**TITEL:** Kontroll av fallskärm

**GÄLLER:** Alla Vector II och III fallskärmar tillverkade mellan 1 januari 1996 och 10 september 1998

**99-01-11 THE UNINSURED RELATIVE WORKSHOP INC.** (doing business as and referred to herein as Relative Workshop): Amendment 39-10977; Docket No. 98-CE-101-AD.

### **AMP Fitting (with grommet) on Breakaway Housings**

Fig. 1 Fig. 2

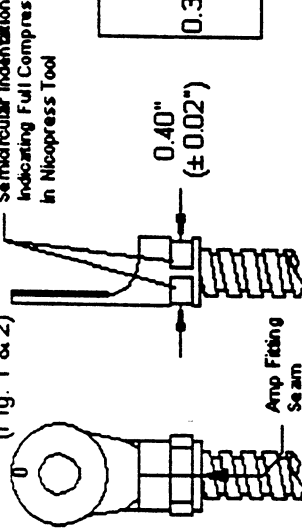
- 1) Remove the heat-shrink tubing surrounding the Amp Fitting and housing.
- 2) Refer to the diagram on Page 2, figures 1 & 2. Determine if your Amp Fitting's swaged indentation resembles these correct diagrams. If so, double check by measuring the indentation diameter per figure 2. The correct dimension is 0.40 inches, +/-0.02 inches. (Refer to Page 2 for metric equivalents)
- 3) If your Amp Fitting resembles the incorrect version, as in Figure 3 & 4, then the Amp Fitting will have to be swaged again using the following procedure.

should not be incorporated into the swage indentation, otherwise the housing and ferrule may be crushed.  
4) Referring to Figure 2, measure the swaged indentation with a set of calipers. The correct dimension is 0.40 inches, +/-0.02 inches.

Fig. 6

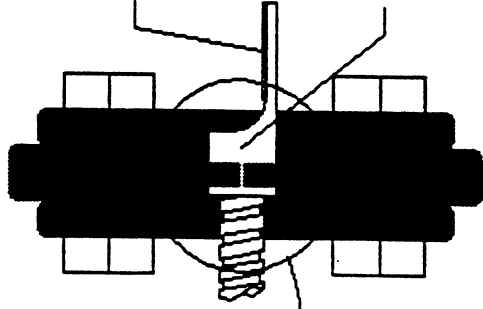
Round End of Amp Fitting  
to Edge of Nicopress Jaw:  
1/16"

Amp Fitting Must Be Oriented in Nicopress Tool as Shown; The Amp Fitting Seam (See Fig. 1) Must Be Up!

DO NOT Swage this Area of the Amp Fitting as this May Crush the Brass Ferrule End of the Housing; See Fig. 7 for a detail of the exact Swaging Location

- 1) Using the NICOPRESS TOOL (64-CGMP or 51-P), place the Amp Fitting into the P-groove; or using the SWAGE-IT TOOL, place Amp Fitting into the 1/8 groove.
- 2) Be sure only 1/16" of the fitting's round end extends beyond the P-groove or 1/8 groove. The fitting must be oriented in the NICOPRESS TOOL as shown in Figure 6 to prevent the Amp Fitting's seam from breaking open.
- 3) Compress the fitting by closing the NICOPRESS TOOL completely. One strike is all that is needed with a properly calibrated NICOPRESS TOOL. The SWAGE-IT TOOL however, should not be closed completely, as this may over swage the AMP Fitting and crush the housing. The housing's ferrule-end
